Figure 4.10.4 View from mid-level apartment in centre of 50 Murray St facade (P2a) - view with proposal inserted is top right image.

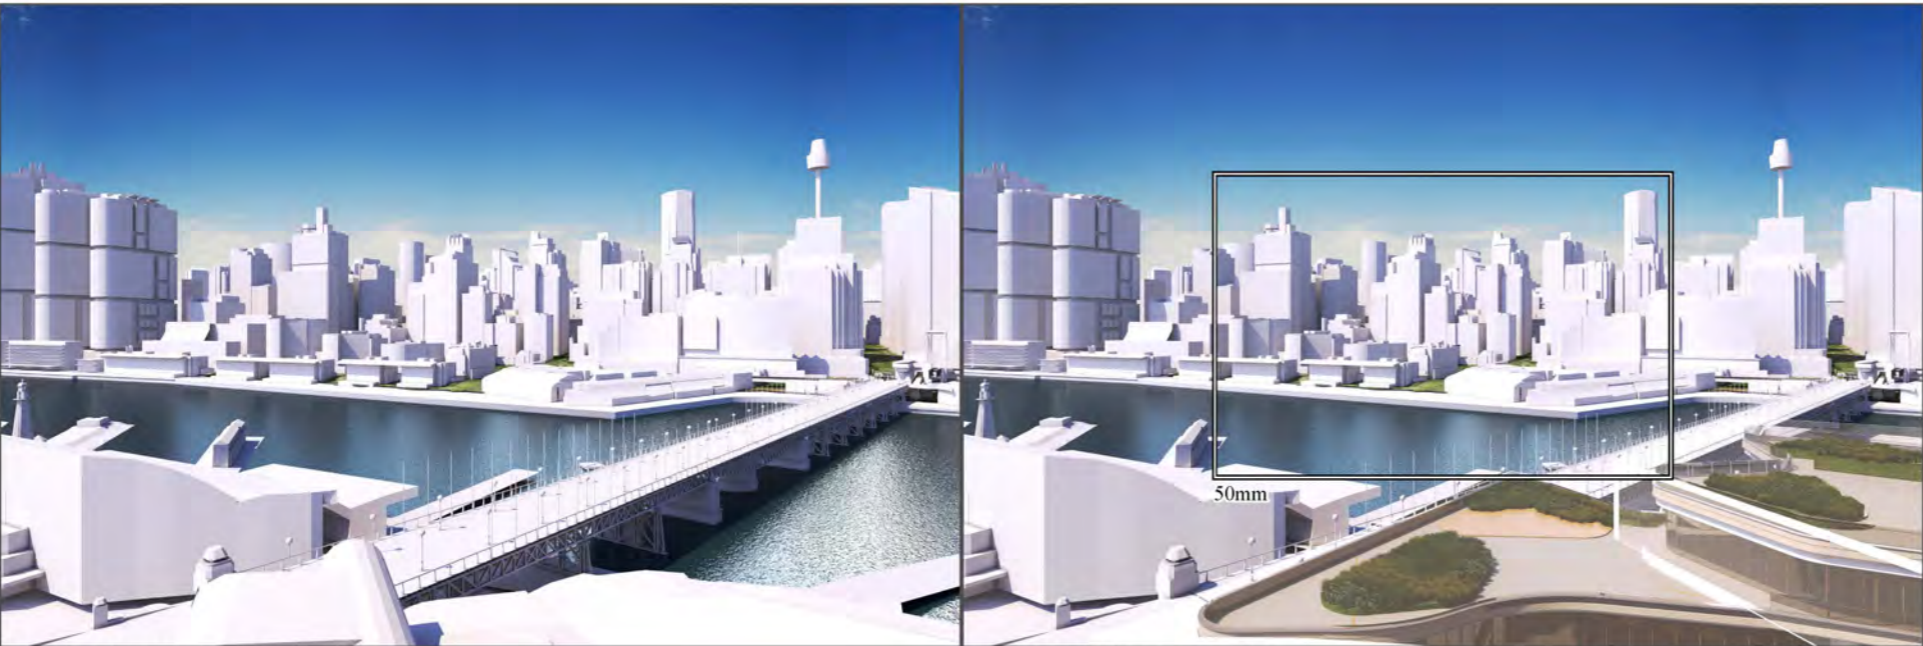
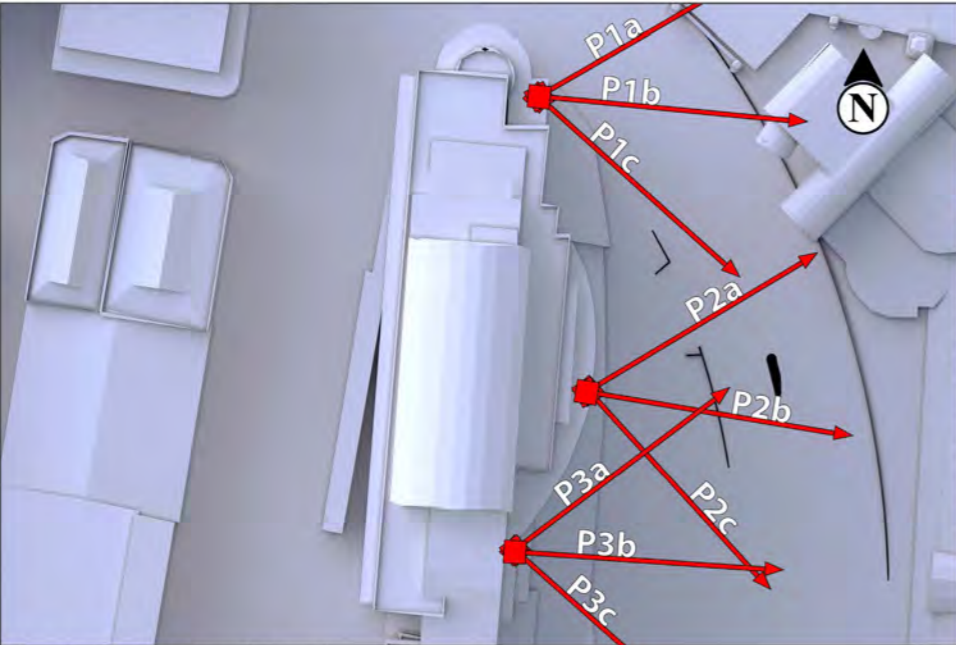
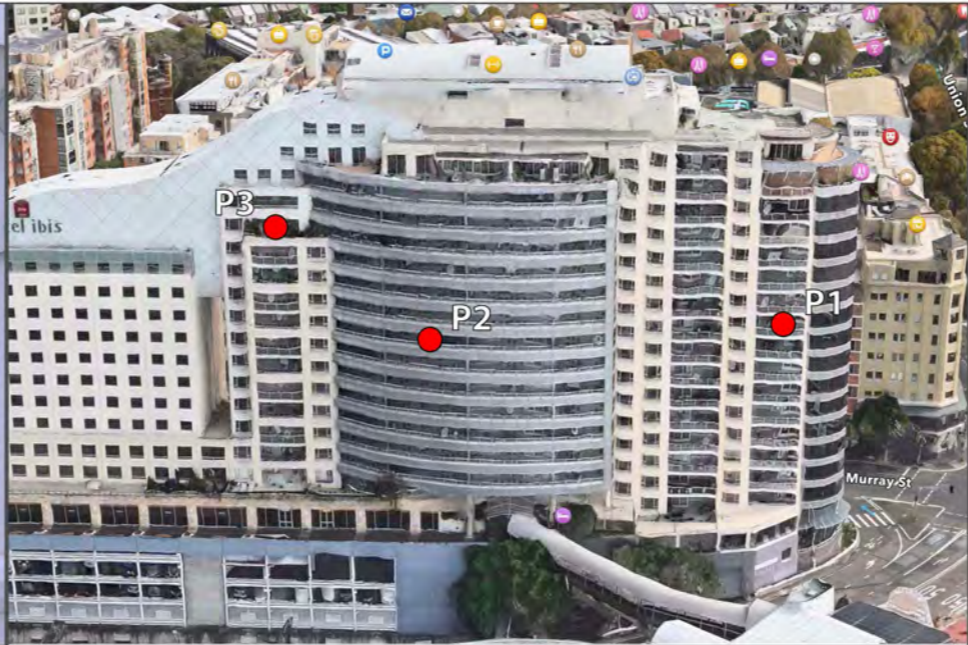
- P2 is an apartment in the central curved portion of the east façade of 50 Murray Street, again at about mid-height. From here the new podium interrupts middle-ground views. However, because the proposed tower is directly opposite and this apartment looks at its narrow western elevation, distant views are less impacted than those from the apartment at P1.
